Document DCO 7.13 / MCO 7.13

# Applicants' Response to Deadline 2 and 3 Submissions

The East Midlands Gateway Phase 2  
and Highway Order 202X and The East Midlands Gateway  
Rail Freight and Highway (Amendment) Order 202X

**Drawing showing controlled crossing option for Works No. 15 alongside the uncontrolled crossing / Capacity analysis of A453 EMA junction including for a controlled crossing**

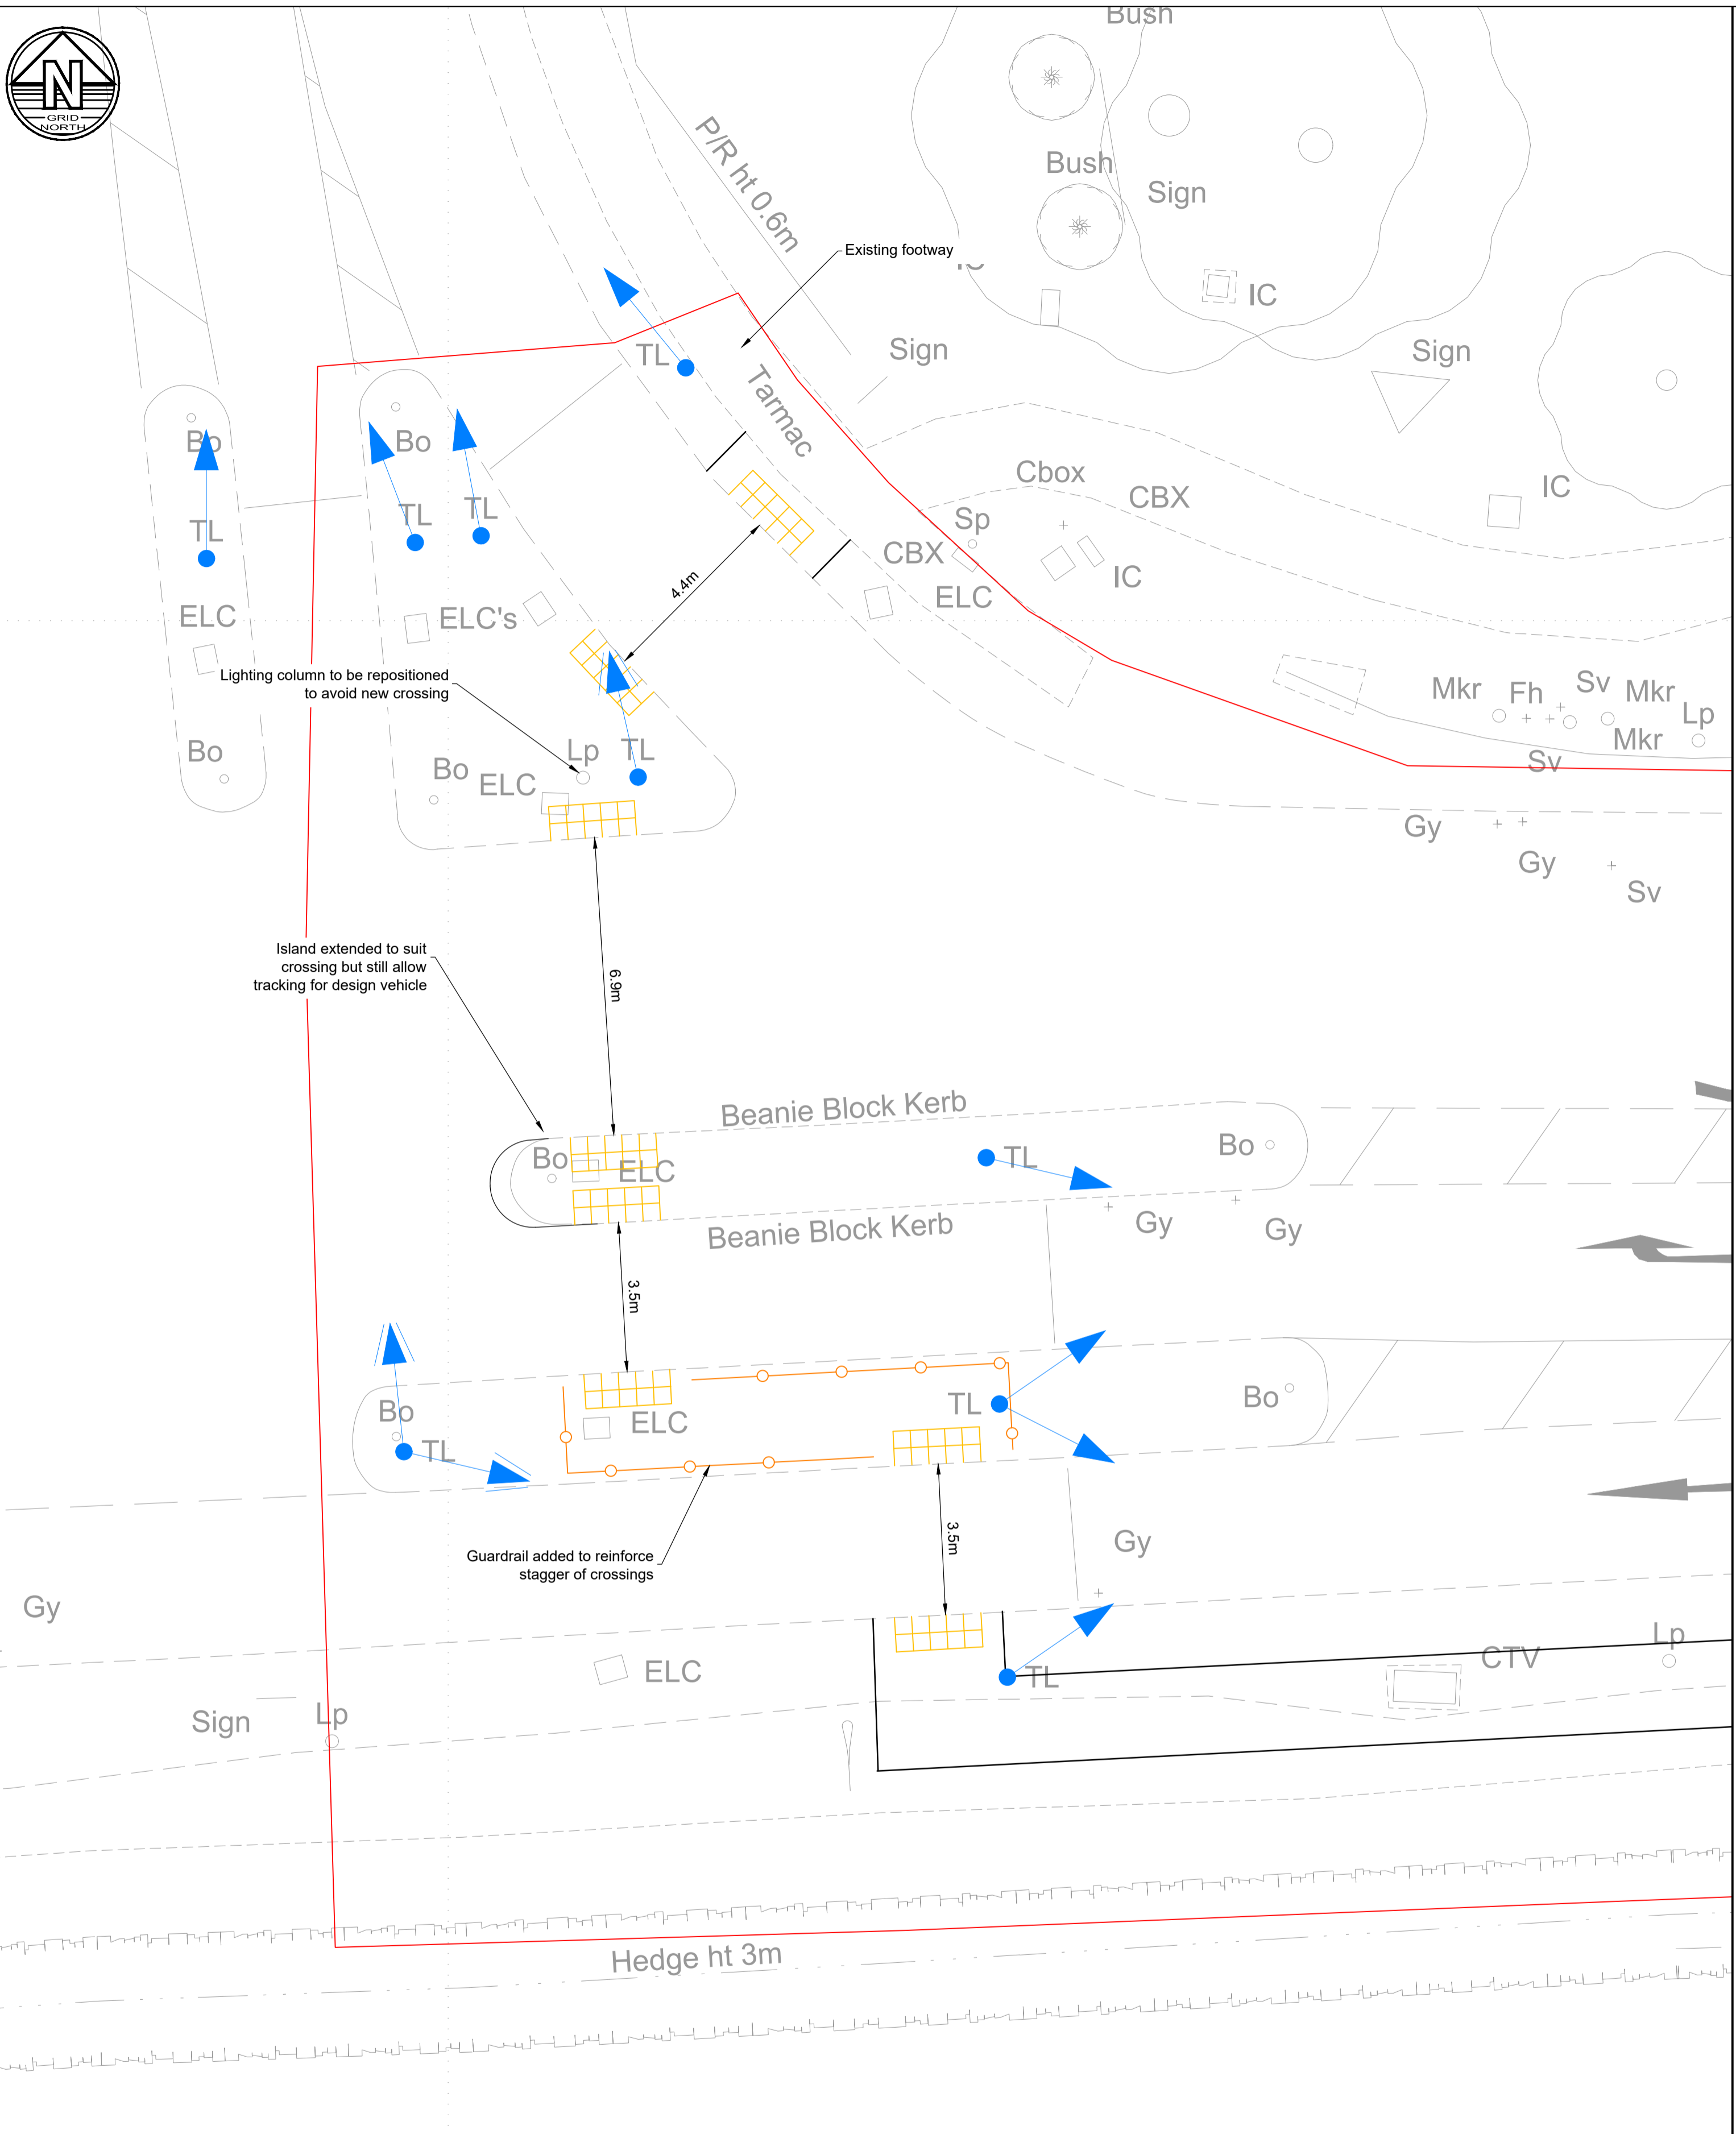
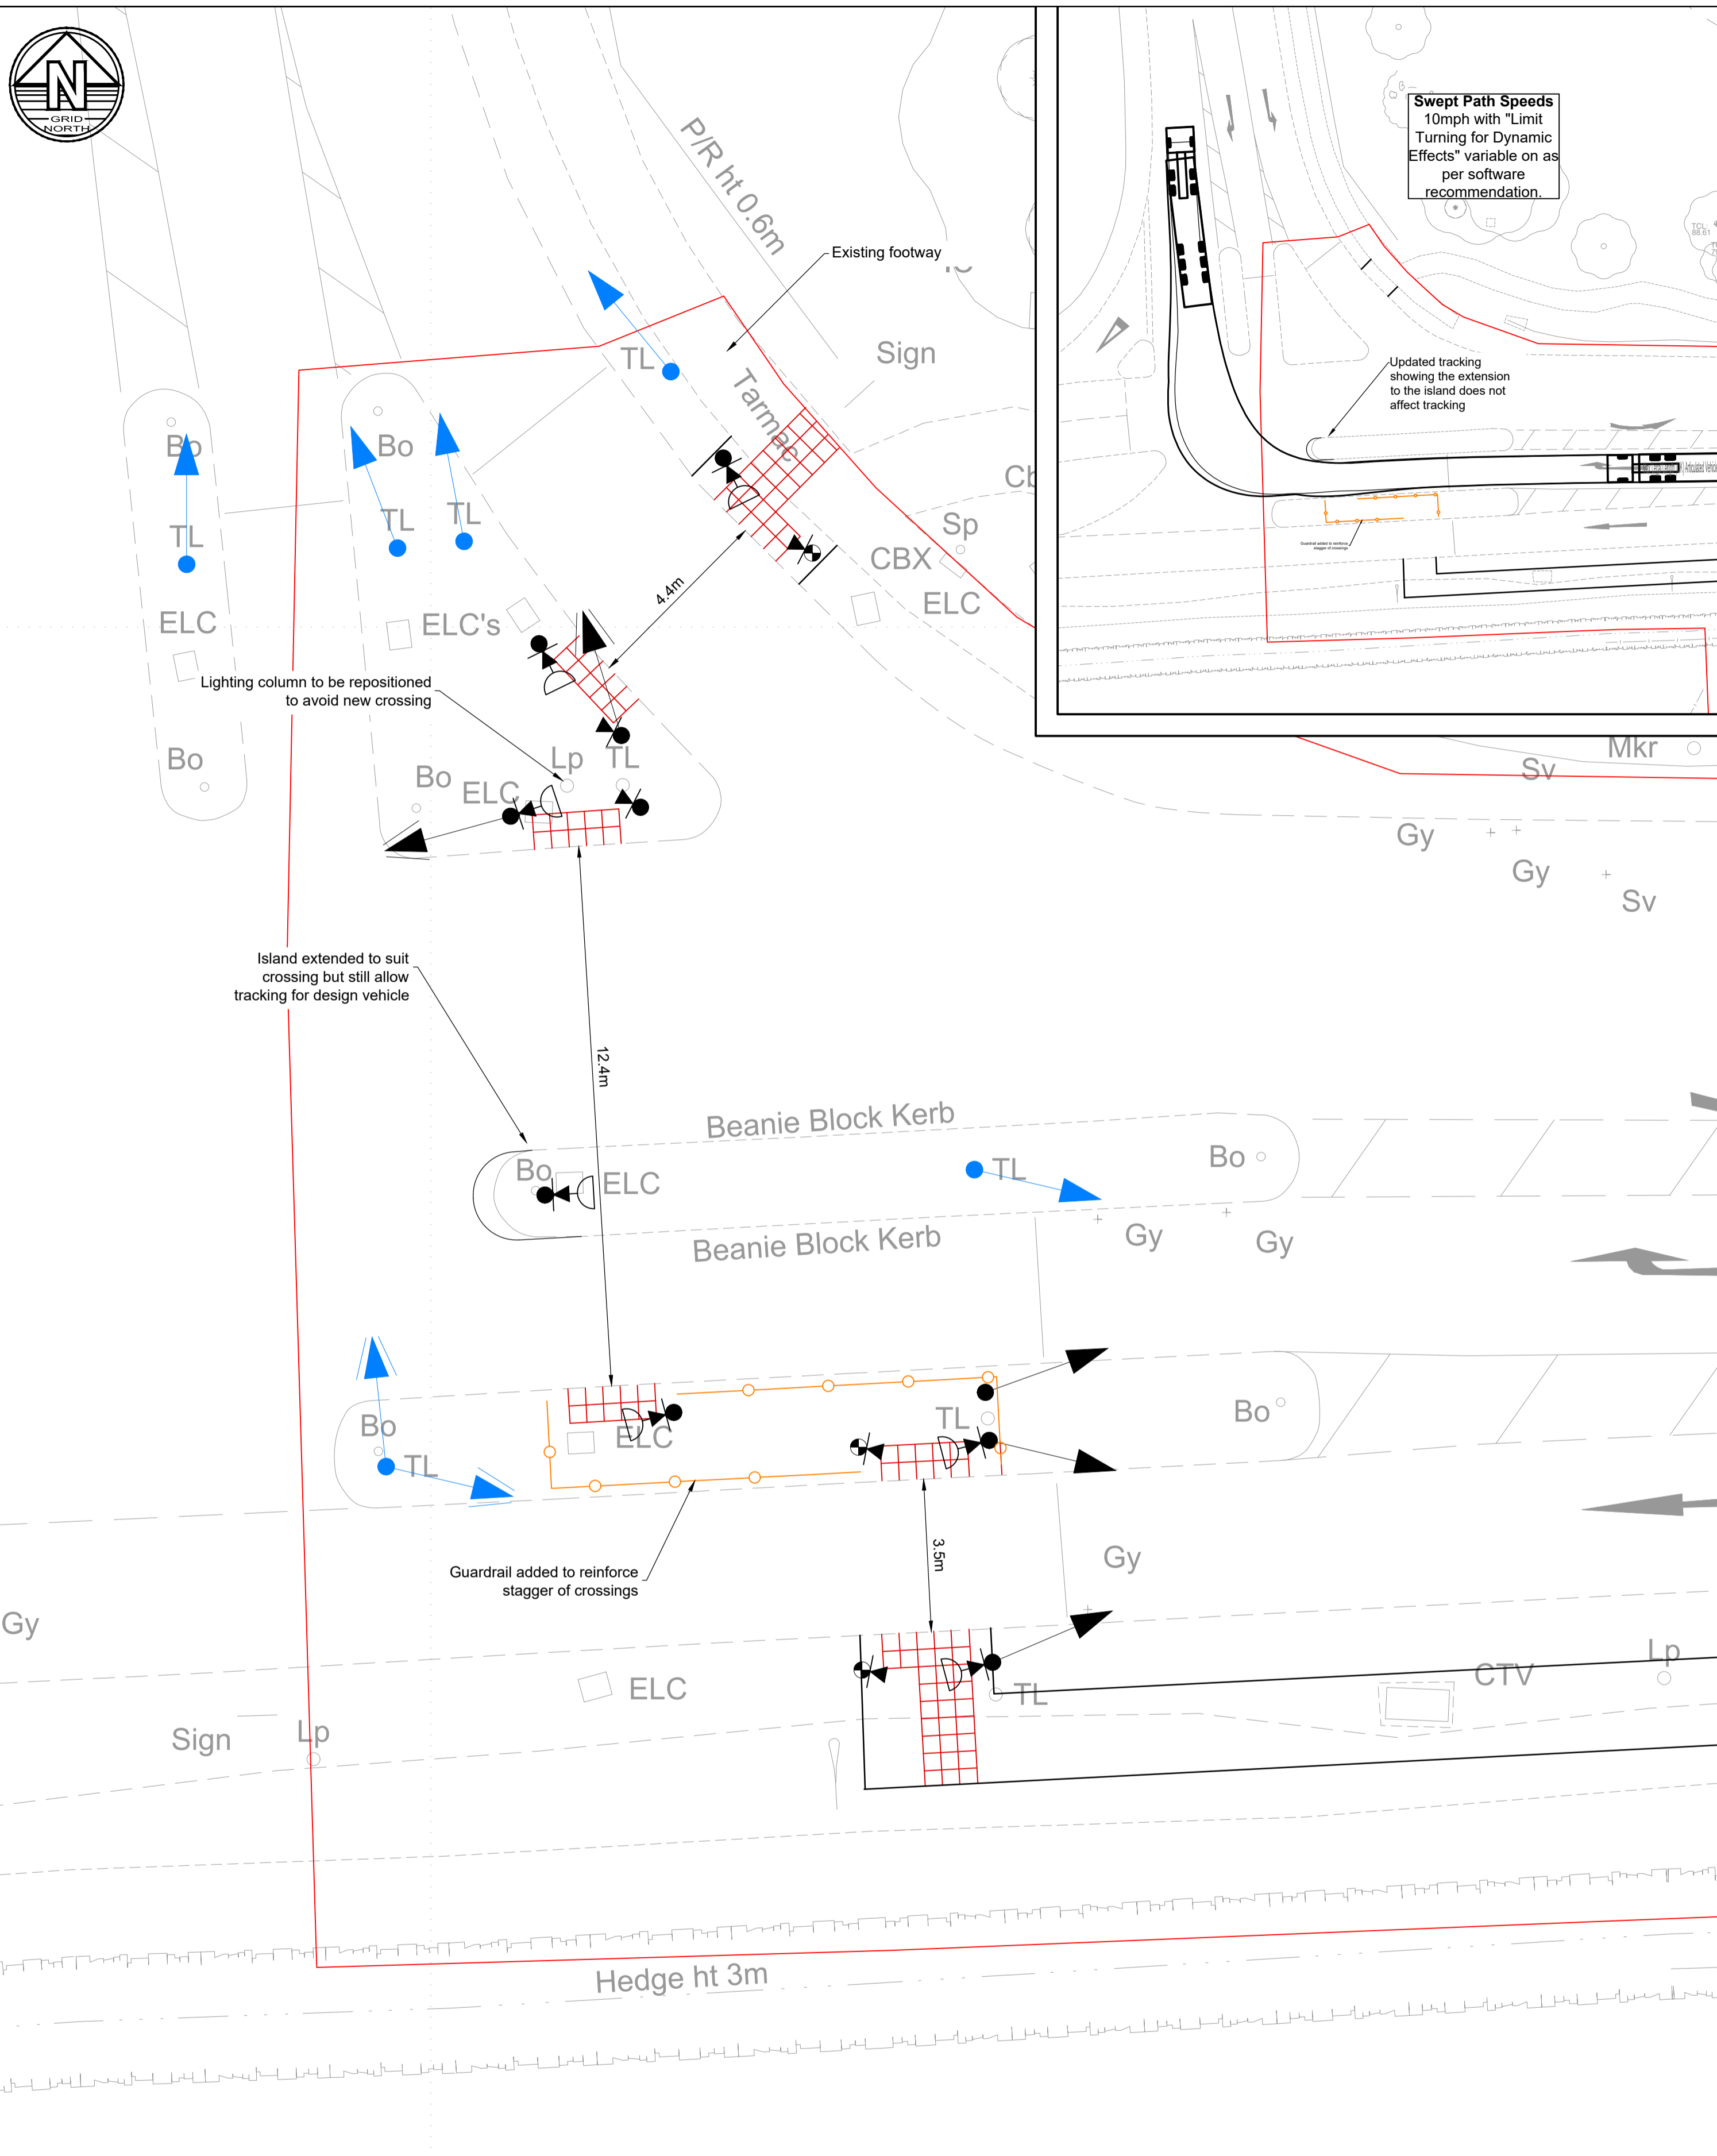
2.	<p>Works Plans Sheet 1 of 4</p> <p>LCC has no comments (other than those made in the responses to the EXP first questions [REP1-088] and Local Impact Report [REP1- 084] regarding Works no 15 (EMA junction uncontrolled crossing)).</p>	<p>The Applicants have worked with LCC to develop a layout for a controlled crossing that can be constructed within the order limits and does not require significant changes to the road layout. A drawing showing the controlled crossing, alongside the uncontrolled crossing, is provided at Annex A. A capacity assessment of this crossing has been produced which confirms that in the very unlikely event there is a crossing demand every cycle, the junction will operate within capacity in all modelled scenarios (i.e. the same modelled scenarios agreed</p>
